QSA GLOBAL

Docket No.: 71-9283 & TAC No. L24256

Subject: RAI Response for Model 660-OP Type B Container

The following is provided in response to your letter dated 3 November 2008 regarding the 660-OP Type B container.

SIZE	DWG. NO.	REV
A	R 66060	D
SCALE	NONE	SHEET 1 OF 3

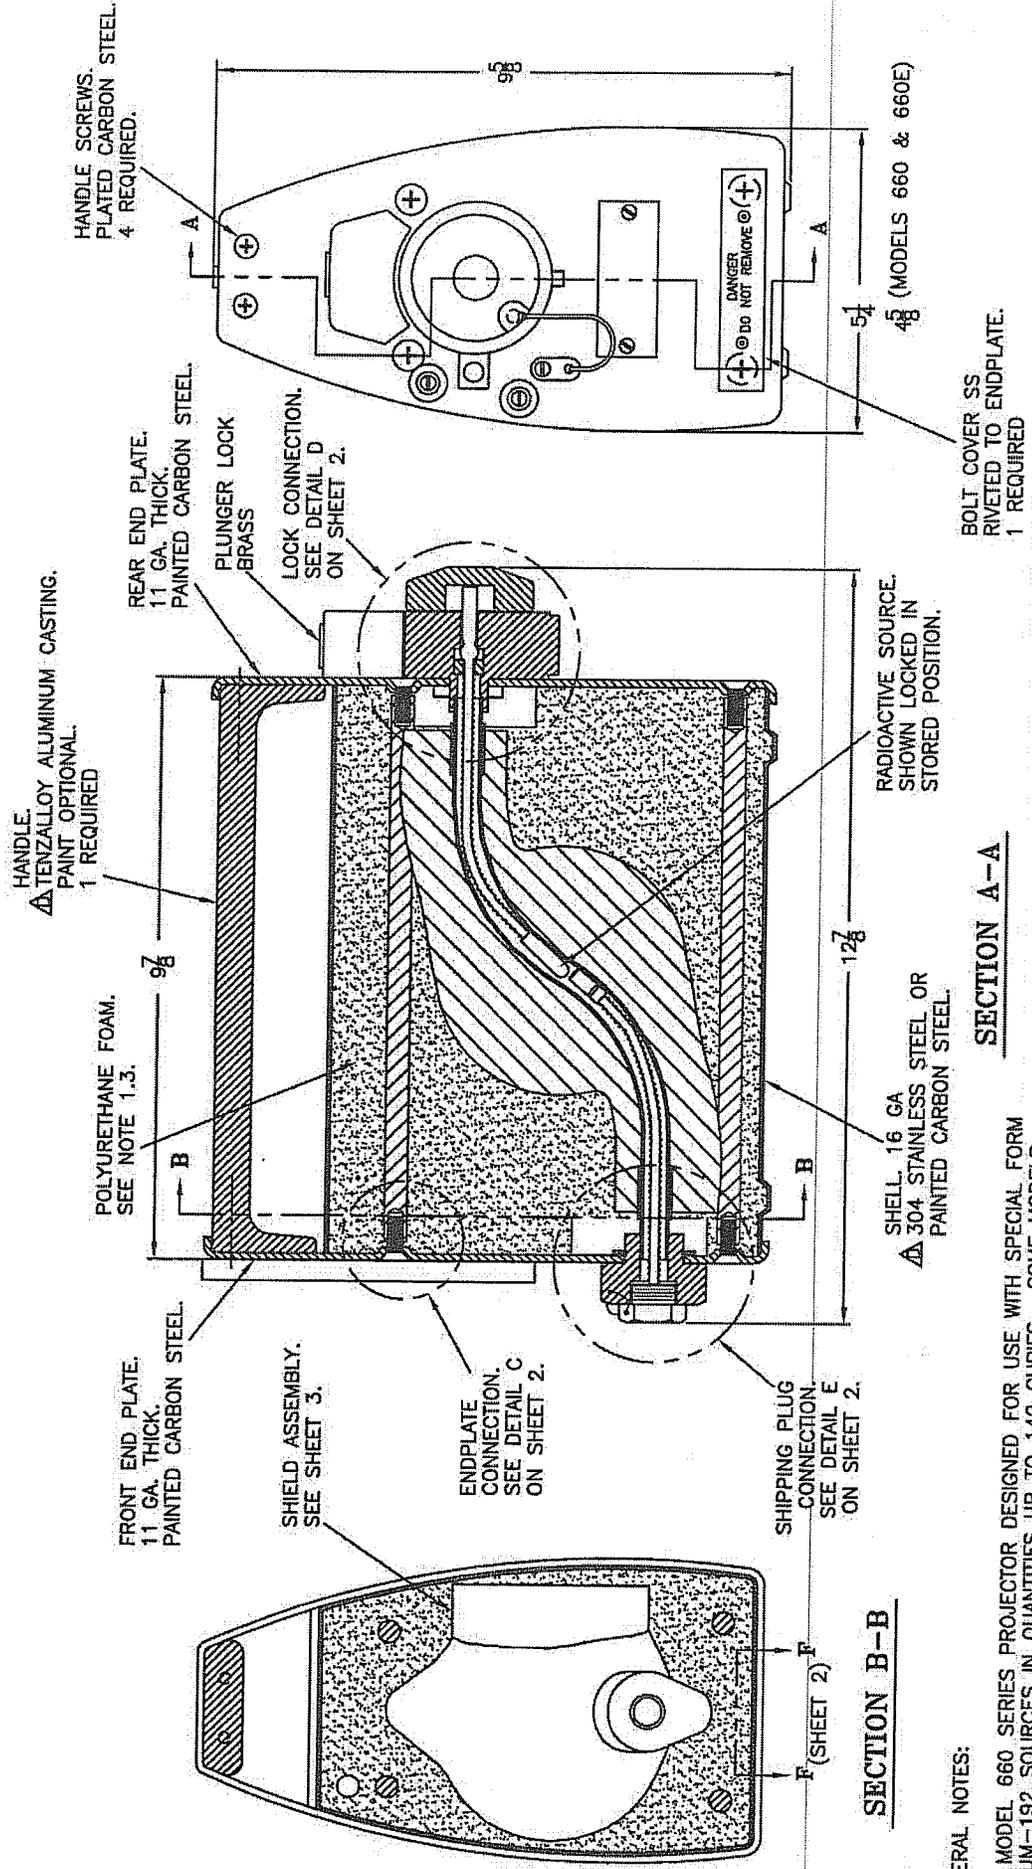
3. Enclosure B includes Drawing R66060 Rev D. Sheet 1, note 1.5 of this drawing has been revised to reference welding and inspection in accordance with MIL SPEC W-6858. This is the welding specification followed for spot welds on the 660 device shell which is the only welding on this device.

7. Note 1.5 on sheet 1 of drawing R66060 Rev D notes that the welding referenced on this drawing reflects historical fabrication. This device had only one weld performed on the device shell and there will be no repair or maintenance performed on the existing device's shell welding. Though now inactive/obsolete, reference to Mil-Spec W-6858 applied at the time of fabrication for existing devices, therefore its remains noted on note 1.5 of the drawing for historical production.

Sheet 1	Note 1.5 of this drawing has been revised to reference welding and inspection in accordance with MIL SPEC W-6858. This is the welding specification followed for spot welds on the 660 device shell which is the only welding on this device. The note also states that this welding documents manufacture of historic product. No future repair or replacement of the 660 shell will be performed for any Type B containers currently in use.	No	No change to package construction or design. Detail added for completeness and clarity only.	None. Not applicable.

Sheet 1	Material specification for the handle is changed from "cast aluminum" to "Tenzalloy Aluminum Casting"	No	No change to package construction or design. Detail added for completeness and clarity only.	None. Not applicable.

Sheet 1	Shell material changed from "Stainless Steel or Painted Carbon Steel" to "304 Stainless Steel or Painted Carbon Steel".	No	No change to package construction or design. Detail added for completeness and clarity only.	None. Not applicable.

DETAIL D (FROM SHEET 1)

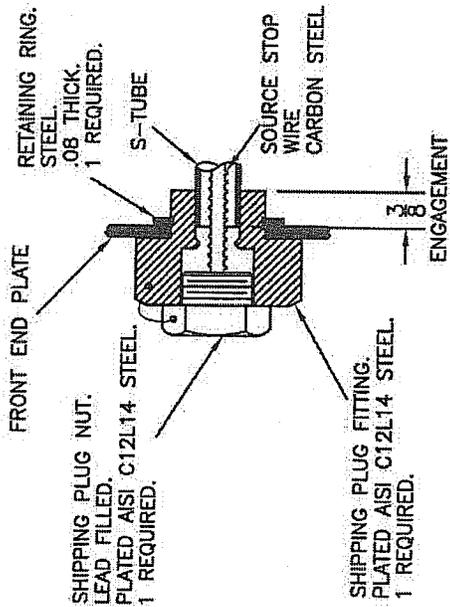
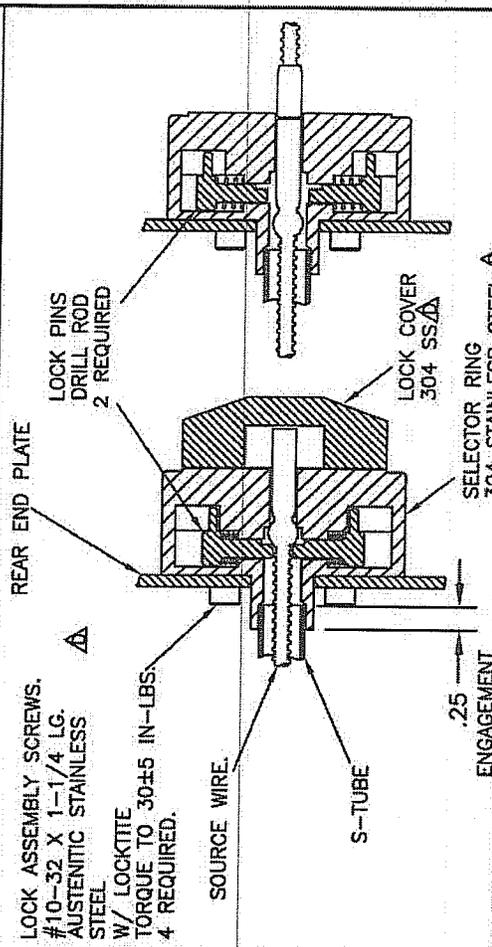
Sheet 2	Revised material for lock slide from "AISI 01 or AISI A2" to read "Flat Ground Stock Oil Hardening Rc 45-55."	No	No change to package construction or design. Detail added for completeness and clarity only.	None. Not applicable.

Sheet 2	Material for lock cover from both the Posilock and Non-Posilock versions of Detail D revised to change the material from "300 Series SS" to read "304 SS".	No	No change to package construction or design. Detail added for completeness and clarity only.	None. Not applicable.

Sheet 2	Material for selector ring from both the Posilock and Non-Posilock versions of Detail D revised to change the material from "300 Series SS" to read "304 Stainless Steel".	No	No change to package construction or design. Detail added for completeness and clarity only.	None. Not applicable.

SECTION F-F (FROM SHEET 1)
SHELL WELD SPECIFICATIONS

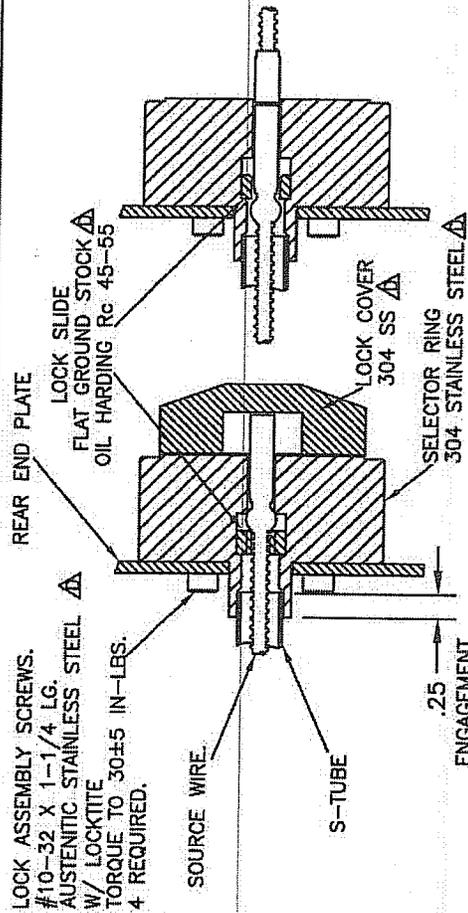
Sheet 2	Material description for the Backing Plate in Section F-F revised from "16 Ga. Thick. Stainless Steel" to read "16 Ga. 304 Stainless Steel"	No	No change to package construction or design. Detail added for completeness and clarity only.	None. Not applicable.

Sheet 2	Weld Note 1 in Section F-F revised to refer to notes on Sheet 1 of the drawing. (Weld specification now covered in Note 1.5 on sheet 1.)	No	No change to package construction or design. Change administrative only.	None. Not applicable.

- WELDING NOTES:
1. SEE NOTES SHEET 1 Δ
 2. SPOTWELD SIZE = 1/8" DIAMETER MINIMUM.
 3. SPOTWELD SPACING = 1 INCH.

SHEET 3 OF 3

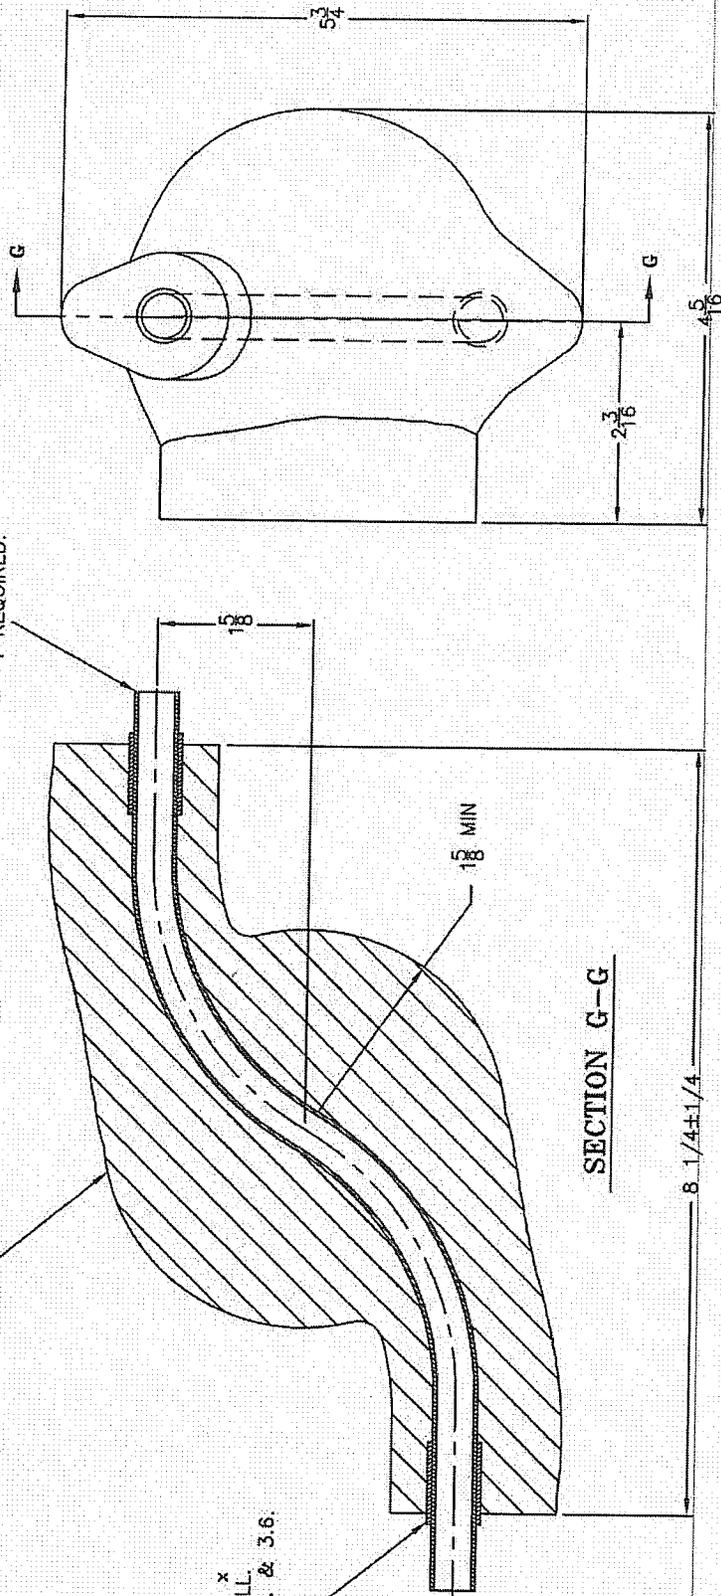
6. The alloy designation for the titanium s-tube has been added to Sheet 3 of Drawing R66060 Rev D. The shield assemblies associated with the 660 series inner devices are no longer being manufactured. At the time these shield assemblies were manufactured, there was no industry standard used to obtain the titanium s-tube material (e.g. ASTM, ASME, etc.). Beginning in September 1992, suppliers of the s-tube material were required to provide a material certification for the source tubes, however, there was no requirement on the production drawing prior to that date and the added requirement in 1992 did not specify conformance to any specific industry standard.

Sheet 3	Material for standard S-tube was changed from "Titanium" to read "Titanium, Ti-3Al-2.5V".	No	No change to package construction or design. Detail added for completeness and clarity only.	None. Not applicable.

- 3.1. MAXIMUM DEPLETED URANIUM WEIGHT = 37 LBS.
- 3.2. MAXIMUM SUPPLEMENTAL LEAD SHIELDING WEIGHT = 3 LBS.
- 3.3. MAXIMUM TOTAL SHIELD ASSEMBLY WEIGHT = 40 LBS.
- 3.4. STANDARD S-TUBE MATERIAL: TITANIUM, Ti-3Al-2.5V ΔΔ
OPTIONAL S-TUBE MATERIAL: ZIRCALLOY
- 3.5. SLEEVE MATERIAL: TITANIUM
- 3.6. S-TUBE AND SLEEVE CAST INTO SHIELD.
- 3.7. MAXIMUM SUPPLEMENTAL LEAD SHIELDING THICKNESS = 1/4 IN.
- 3.8. LEAD ADDED AROUND SHIELD SURFACE.
